ADDENDUM 2

DATE: February 22, 2017
PROJECT: JLL Roof Replacement and Waterproofing Project
RFP NO: 744-R1712
OWNER: The University of Texas Health Science Center at Houston
TO: Prospective Proposers

**UNIVERSITY OF TEXAS HEALTH SCIENCE CENTER
JESSE JONES LIBRARY
ROOF REPLACEMENT AND EXTEIOR WALL REPAIRS/RESTORATION
1133 JOHN FREEMAN BOULEVARD
HOUSTON, TEXAS**

**ADDENDUM NO. 1
FEBRUARY 17, 2017**

DWN.BY: ESG
DATE: 01/20/17
SHEET: R3.00

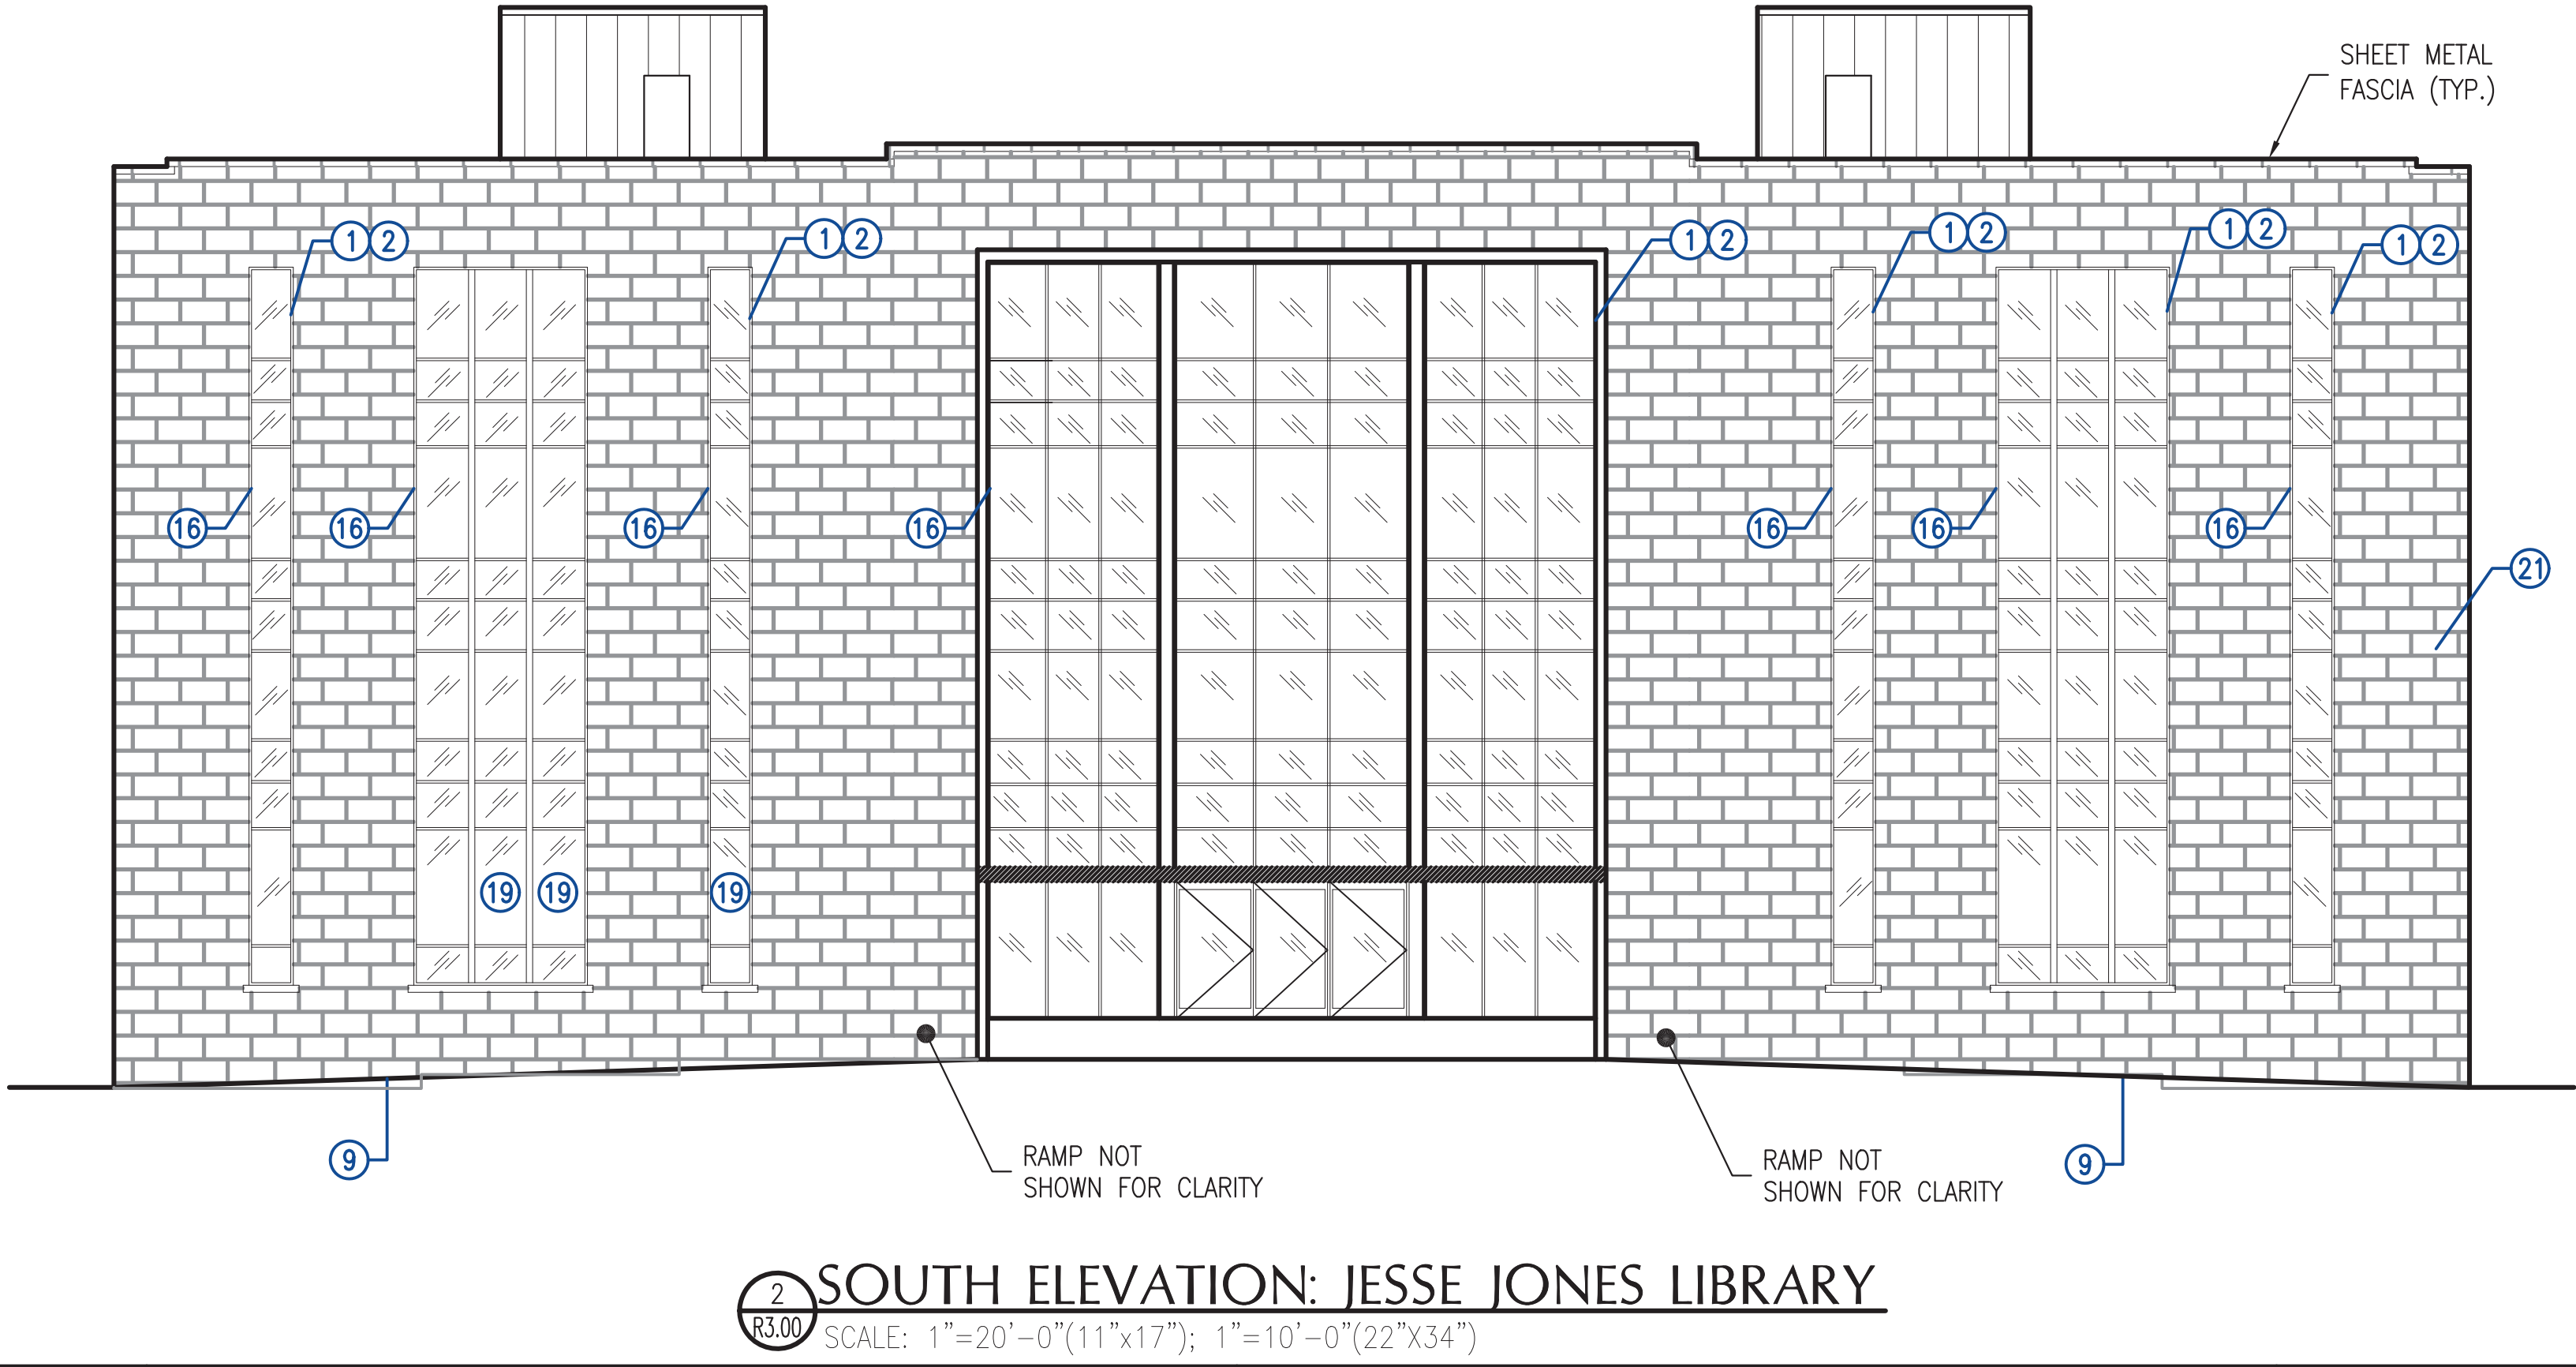
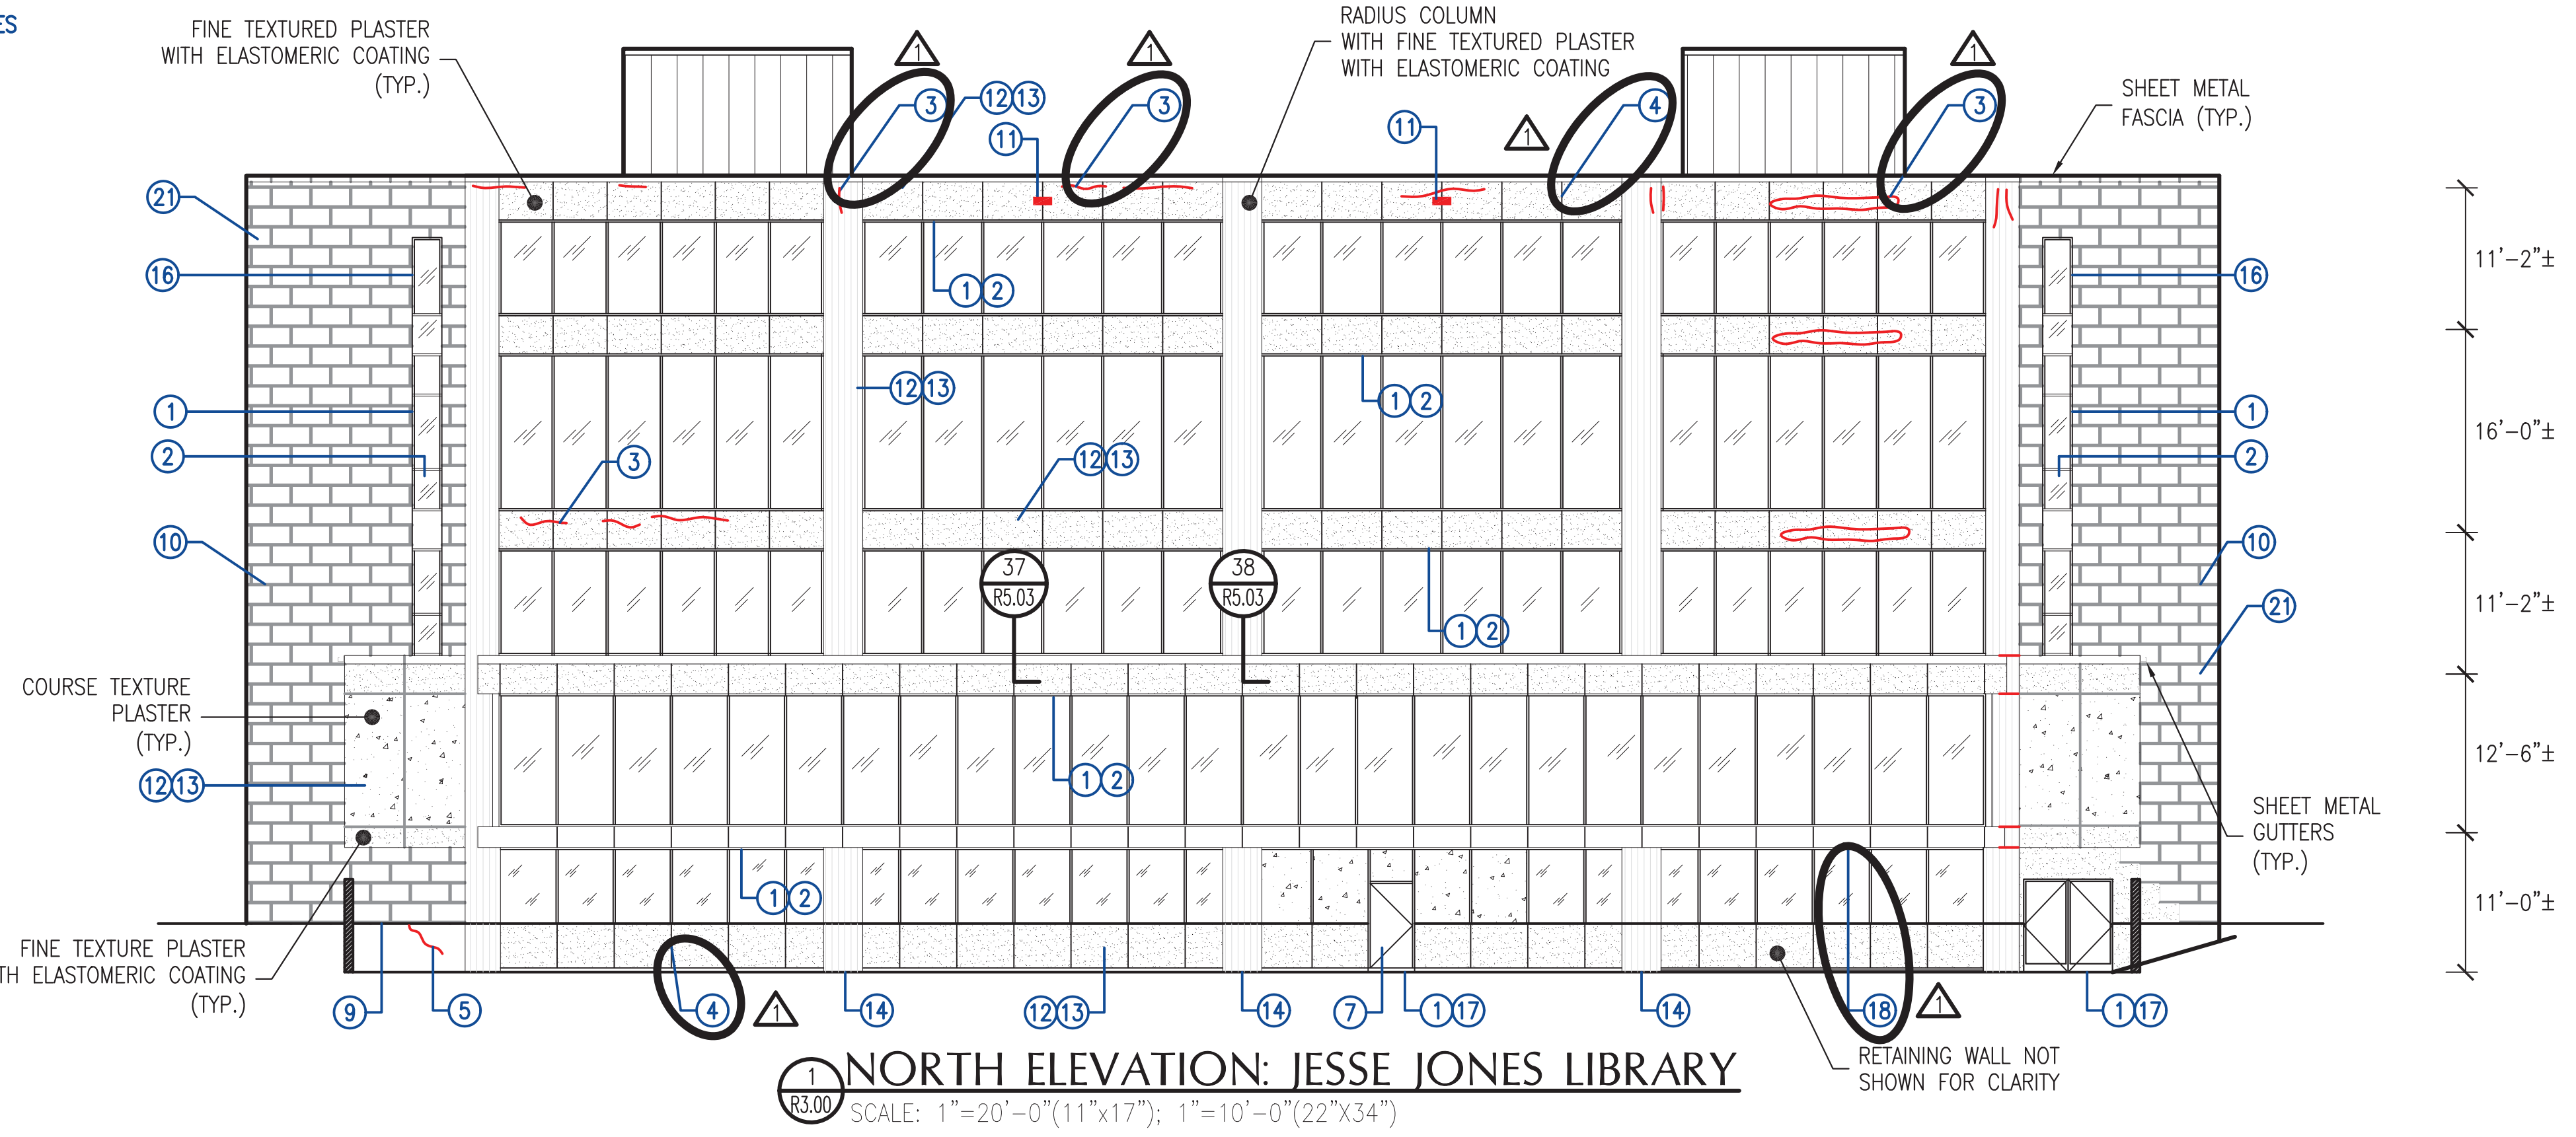
8. Sheet R3.00 – Elevations: Elevation 1/R3.00: Change Repair Note designation “4” to “3” on elevation; Add Repair Note “4” designation at respective locations on elevation; Add Repair Note “18” to underside of floor slab at lower level walkway at respective locations on elevation. Reference attached revised Sheet R3.00.

1 EAST ELEVATION: JESSE JONES LIBRARY

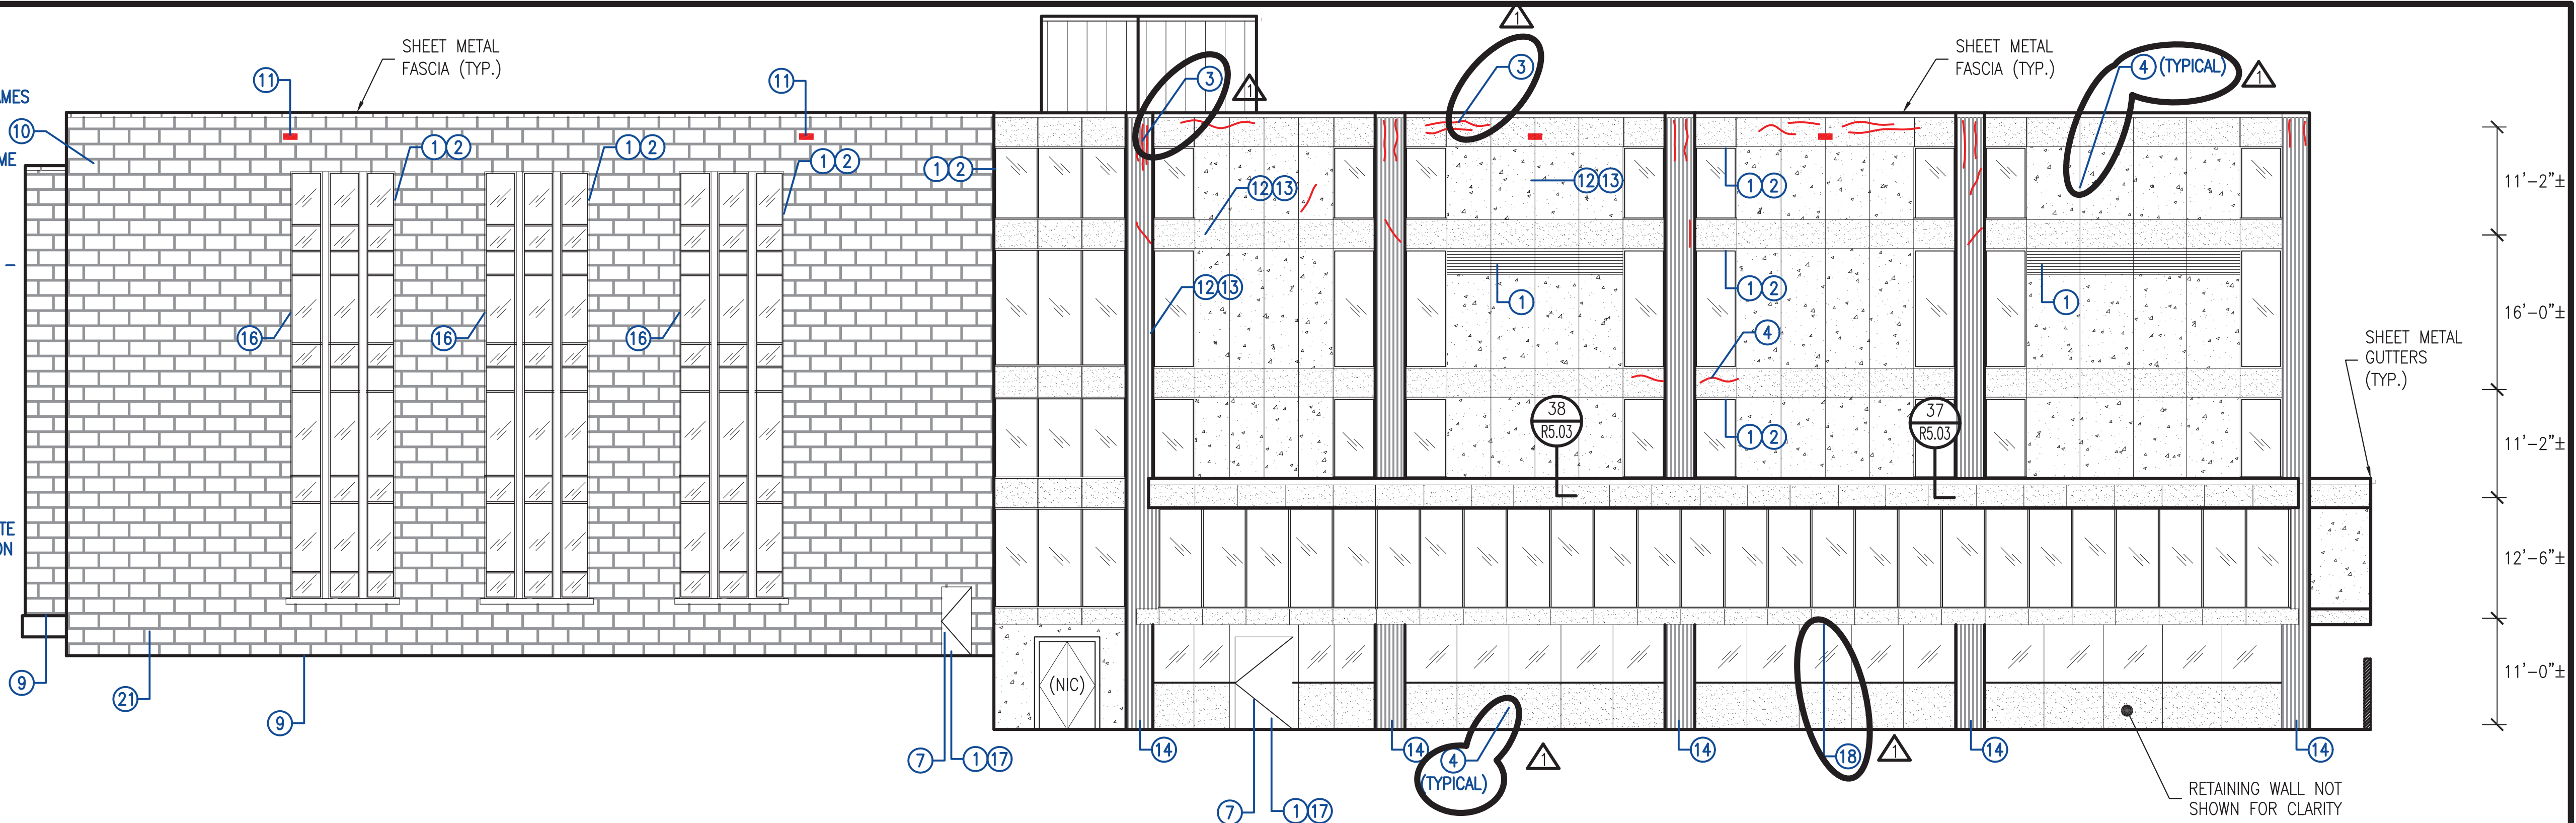
9. Sheet R3.01 – Elevations: Elevations 1/R3.01 and 2/R3.01: Change Repair Note designations “4” to “3 on elevations; Add Repair Note “4” designation at respective locations; Add Repair Note “18” to underside of floor slab at lower level walkway at respective locations on elevations. Reference attached revised Sheet R3.01.
